Response to Submissions Report

270 Miller Street, North Sydney
Marist Catholic College North Shore
SSD 10473

Submitted to Department of Planning and
Environment
On behalf of Sydney Catholic Schools

17 June 2022 | 218786

Figure 3 – Current (November 2021) Church Precinct landscape design

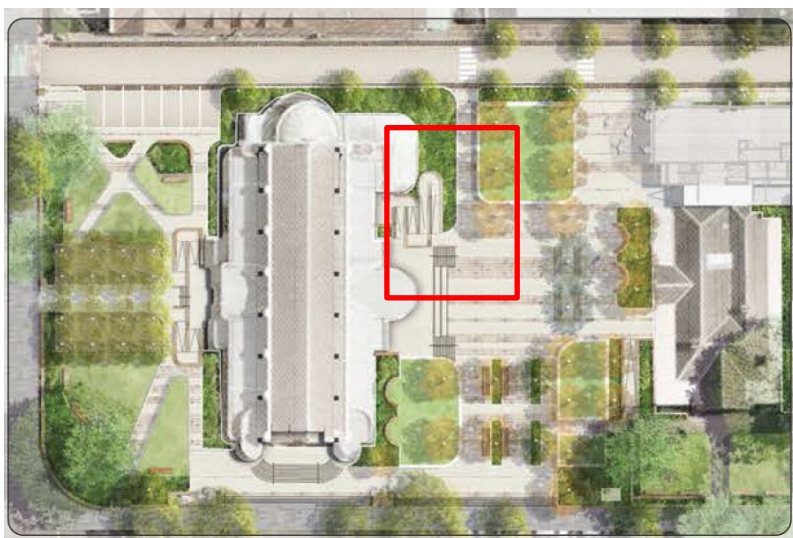
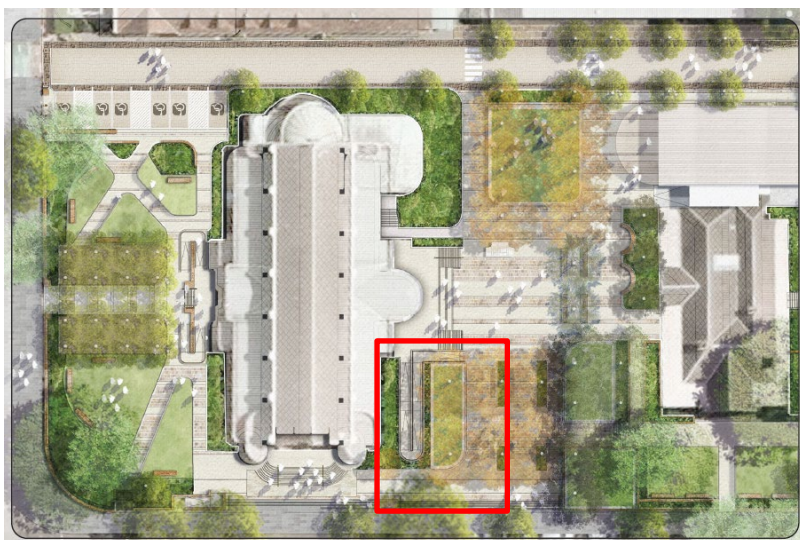
Through ongoing design development and in response to feedback received from DPE and GA NSW, several minor amendments have been made to the landscape design. These include:

- Minor changes to tree plantings to increase tree canopy cover to 26%, compared to the existing tree canopy coverage of approximately 22%.
- Simplification of the line markings and colours on the multi-purpose sports court.
- Replacement of the street trees on Carlow Street with a deciduous species (*Fraxinus pennsylvanica*) to maximise winter sun to the adjacent undercroft COLA.
- Minor changes to the Church Garden including removal of intrusive pebblecrete pathways and replacement with a granite paver that is more in keeping with the heritage significance of the Church.
- Relocation and rationalisation of the pedestrian ramp on the eastern side of St Mary's Church (refer to **Figures 3 and 4**).

Figure 4 – Proposed Church Precinct landscape design

Figure 7 – Child care centre open space perspectives and solar access

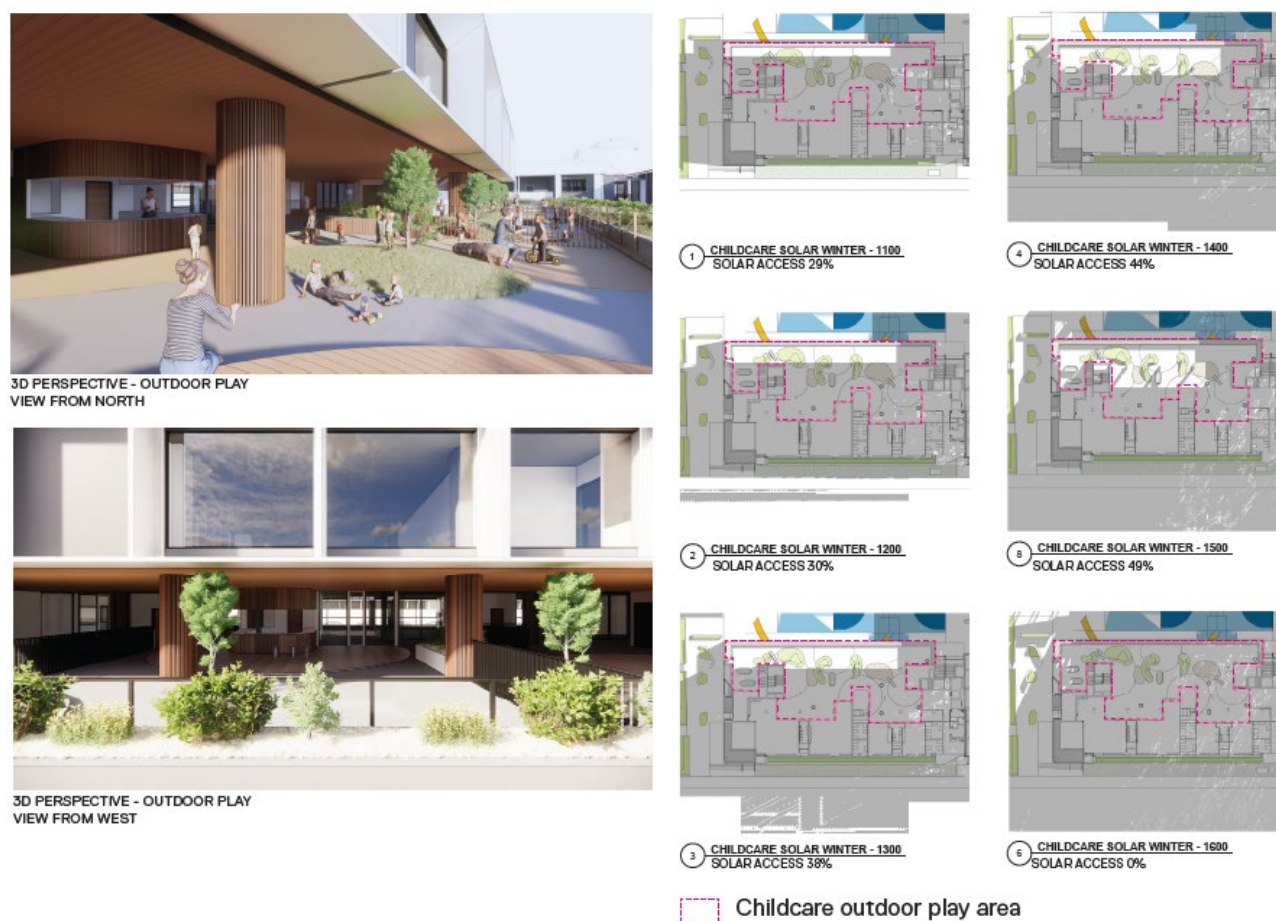
<p>Demonstrate that the Early Learning Centre outdoor area will perform in accordance with the NSW Child Care</p>	<p>Refer to response at Section 4.</p>

Comment	Response
Planning Guideline which states that outdoor play areas should have year-round solar access to at least 30% of the ground area, with no more than 60% of the outdoor space covered.	<p>The child care centre is located at Level 1 of the Miller Street building. WMK has confirmed that 40% of the outdoor space is open directly to the sky, with the remaining 60% of the outdoor space covered by the floor above.</p> <p>The outdoor play area has been consolidated on the western side of the child care centre to maximise access to direct uninterrupted sunlight between 11am and 3pm, including at mid-Winter. WMK has confirmed that at least 30% (see Figure 7) of the outdoor area will receive solar access on the Winter Solstice. In addition, the glazed eastern facade allows the centre to receive ambient daylight throughout the day, providing natural light into the play spaces.</p> <p>It is noted that the Regulatory Authority (Department of Education) has already granted concurrence with respect to the provision of unencumbered outdoor space under section 3.22 of the TI SEPP (formerly clause 22 of the Education SEPP).</p>

The child care centre is located at Level 1 of the Miller Street building. WMK has confirmed that 40% of the outdoor space is open directly to the sky, with the remaining 60% of the outdoor space covered by the floor above. The outdoor play area is a large verandah space that has been designed in accordance with the NSW Child Care Planning Guidelines. The proposed open space design provides children with additional experiential environmental learning, and opportunities to have both covered and uncovered outdoor play. Perspectives of the outdoor space are provided at **Figure 7**.

The outdoor play area has been consolidated on the western side of the child care centre to maximise access to direct uninterrupted sunlight between 11am and 3pm, including at mid-Winter. WMK has confirmed that at least 30% of the outdoor area will receive solar access on the Winter Solstice during the hours of active outdoor play (see **Figure 7** below). In addition, the glazed eastern facade allows the centre to receive ambient daylight throughout the day, providing natural light into the play spaces.

Figure 8 – Early aerial photograph over the site with the HCA outlined in red and the former school building outlined in blue

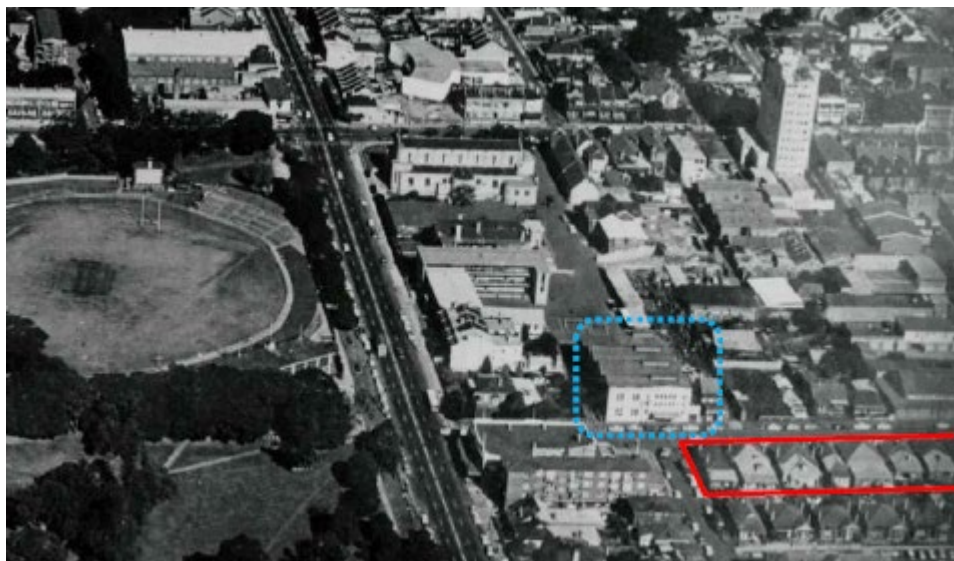
Issue Raised	Submitter	Response
considered a mitigation measure.		
No reference is made to CA18 - Holterman Estate D, needing the HIS to include a description of the relevant portion of this HCA, statement of significance and discussion of potential impacts of proposal on HCA.	DPE	<p>Weir Philips has provided a description of the Holterman Estate D HCA and an assessment of the potential impacts on the HCA. In summary:</p> <ul style="list-style-type: none"> • The section of the HCA in the vicinity of the site adjoins a small section of the site on the opposite side of Carlow Street. There are direct view corridors across Carlow Street between the HCA and the proposed works. • The proposed works adjacent to the HCA includes removal of the existing structures on the school site opposite the HCA and construction of a new, four-storey (above ground) building. • The proposed works will have an acceptable impact on the HCA for the following reasons: <ul style="list-style-type: none"> - The school buildings currently opposite the HCA on Carlow Street present as a diverse mix of buildings with little or no architectural merit. The existing structures poorly address the HCA and provide little or no consideration to the significance of the HCA opposite. - The proposed scheme provides a considered, coordinated and more sympathetic architectural resolution, and will enable an enhanced understanding and appreciation of the HCA. - The proposed design is a highly considered, articulated and contemporary architectural scheme that is clearly stylistically separate to the HCA but incorporates a palette of materials, finishes and a third storey setback that provides a height, form and scale that is in keeping with the HCA. - The proposed school buildings are behind the main northern view corridors to the HCA and do not block or obscure this view corridor. - Carlow Street is planted with mature London Plane Trees that provide a visual buffer to the proposed works and the HCA. - Finally, historical photographs have shown that prior to the current building fronting Carlow Street, there was a substantial three-storey building opposite the HCA. This building had a similar form, bulk and scale as the proposed building.

Finally, historical photographs have shown that prior to the current building fronting Carlow Street, there was a substantial three-storey building opposite the HCA. This building had a similar form, bulk and scale as the proposed building (refer to **Figure 8**).

Figure 13 – Solar access to the Carlow Street undercroft (Winter Solstice)

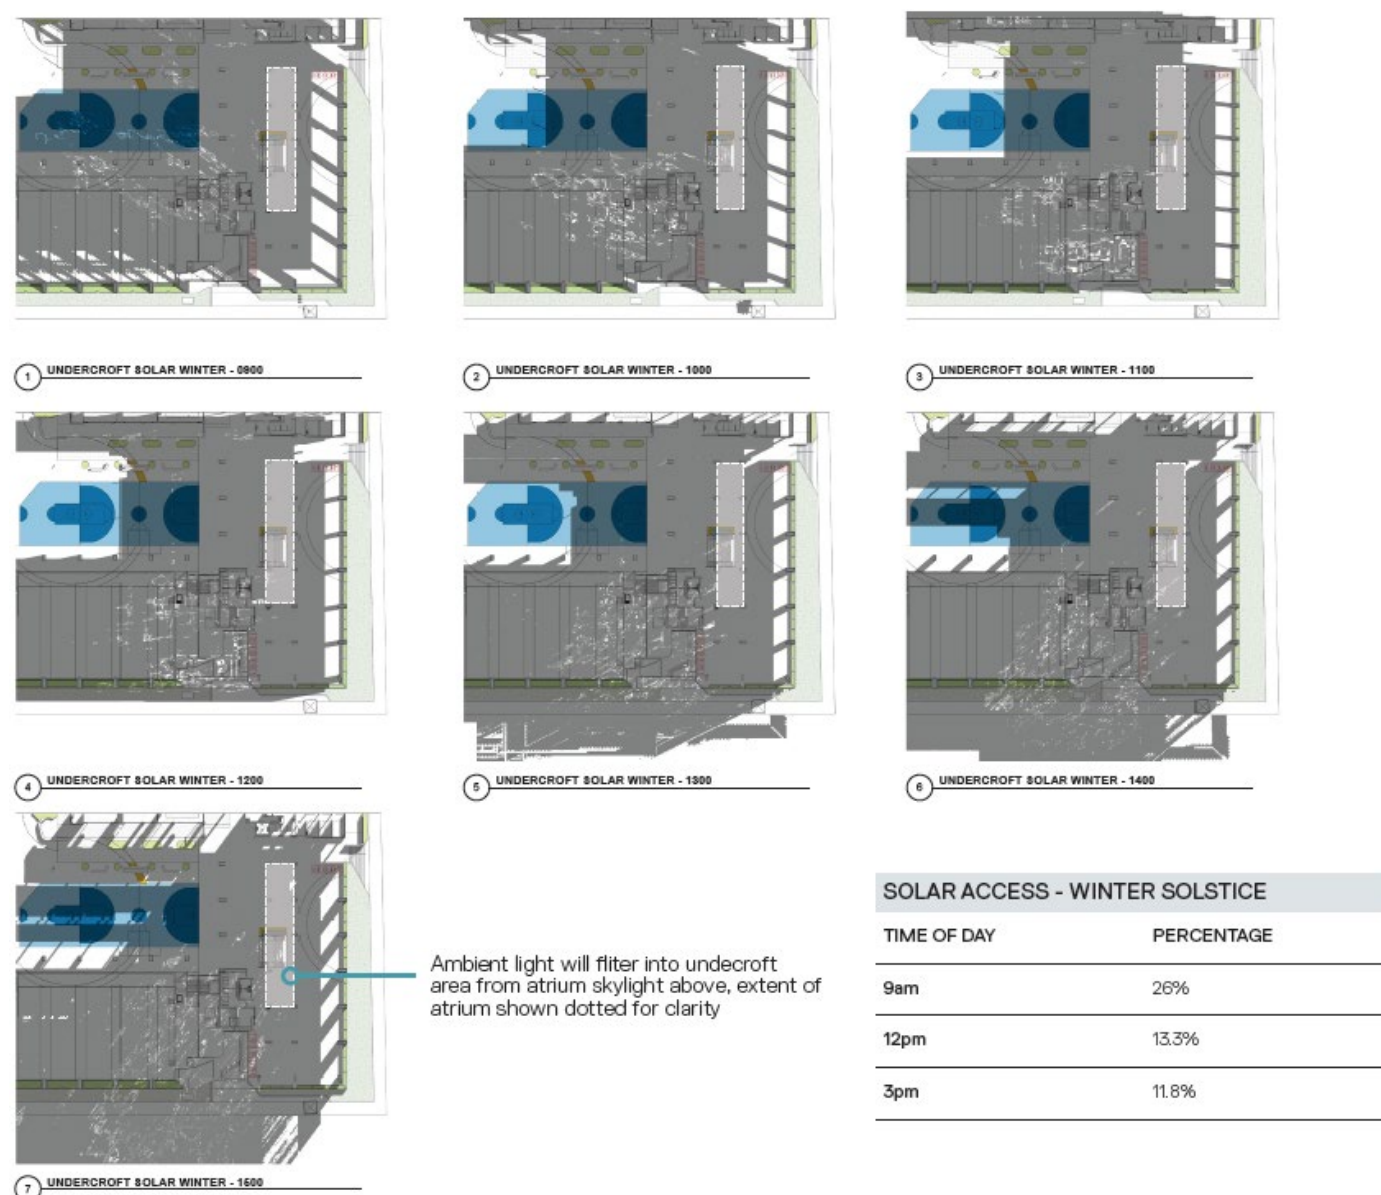
In response to concerns raised by the NSW SDRP, additional consideration has been given to the amenity of the Carlow Street undercroft, particularly with respect to solar access on the Winter Solstice and the acoustic amenity of the space.

Comment	Response
<p>The large undercroft areas require further design development to ensure that a high level of amenity is achieved, attracting year-round use. Address the issues of solar access and acoustic comfort in the Carlow Street building Covered Outdoor Learning Area (COLA) and Early Learning Centre outdoor play area.</p>	<p>Refer to response at Section 4.</p> <p>The solar studies are shown in the Architectural Design Report at Appendix B and are replicated above at Figure 13. The undercroft play space has been designed to provide comfort in both the summer and winter months by balancing the need for shade in the summer and warmth in winter.</p> <p>During winter, the sun penetrates through the northern façade to allow for warmth and sunlight into the space. Solar access is available to parts of the COLA throughout the day, as follows:</p>
<p>Reorganise the planning and built form to provide a greater sense of height, increase solar access to the covered outdoor spaces in winter and provide outlook to the sky from the COLA; For example, the Student Support Area at the northern end of the campus could be relocated to enable a double-height termination to the north/south axis, improving solar access to the COLA.</p>	<ul style="list-style-type: none"> • 9am - 26% • 12pm – 13.3% • 3pm – 11.8% <p>The space will receive a combination of direct and ambient/indirect sunlight, allowing for flexibility and a range of uses.</p> <p>Direct sunlight will provide warmth to the space for relaxation, and respite for staff and students who will generally spend most of their time indoors with indirect sunlight. As shown at Figure 13 above, there are other areas within the site which will receive direct solar access on the Winter Solstice, providing opportunities for students to access direct sunlight when the undercroft is shaded.</p>

<p>Provide sun studies illustrating the area of solar access to the ground plane (as a percentage of the total covered area) from 9am to 3pm in mid-winter.</p>	<p>The ambient/indirect light will provide:</p> <ul style="list-style-type: none"> • Even lighting, reducing glare and dark spots. • Preferred comfort levels for working and holding classes and/or flexible learning workshops. • Outdoor recreation spaces outside of direct sunlight. • Increased indirectly lit and shaded areas in the summer months, responding to and balancing the differing cooling and heating requirements in the undercroft area from winter to summer. • A non-air conditioned, shaded outdoor area in summer for informal learning as part of the proposal's ESD strategy.
	<p>In response to feedback from the SDRP:</p> <ul style="list-style-type: none"> • The street trees on Carlow Street are now a deciduous species (<i>Fraxinus pennsylvanica</i>) to maximise winter sun to the adjacent undercroft space. • A solar study has been performed reviewing the scenario of relocating the student services at the northern end of the building. Although additional direct daylight is provided, it is relatively minor and represents no substantial solar benefit to the undercroft and quadrangle area in terms of the solar access benefits outlined above. <p>With respect to the acoustic amenity of the undercroft space, WMK has taken precedent from the Northern Beaches Christian School where an acoustic solution has been implemented and adopted for a similar undercroft play space. Acoustic design solutions that have been implemented include:</p> <ul style="list-style-type: none"> • Acoustic lining to the underside of the soffits diminishes the noise and reverberation within the space. • Soft planting is used to create a barrier between the differing areas, and to assist in dampening noise/sound. • Textured finishes and soft surfaces are used on the loose furniture to absorb sound. <p>Based on the above, it is considered that the amenity of the COLA is adequate with respect to solar access and noise, and the undercroft will provide a high quality open space for learning and recreation during both the winter and summer months.</p>

The solar studies are shown in the Architectural Design Report at **Appendix B** and are replicated below at **Figure 13**. The undercroft play space has been designed to provide comfort in both the summer and winter months by balancing the need for shade in the summer and warmth in winter.

Direct sunlight will provide warmth to the space for relaxation, and respite for staff and students who will generally spend most of their time indoors with indirect sunlight. As shown at **Figure 13**, there are other areas within the site which will receive direct solar access on the Winter Solstice, providing opportunities for students to access direct sunlight when the undercroft is shaded.
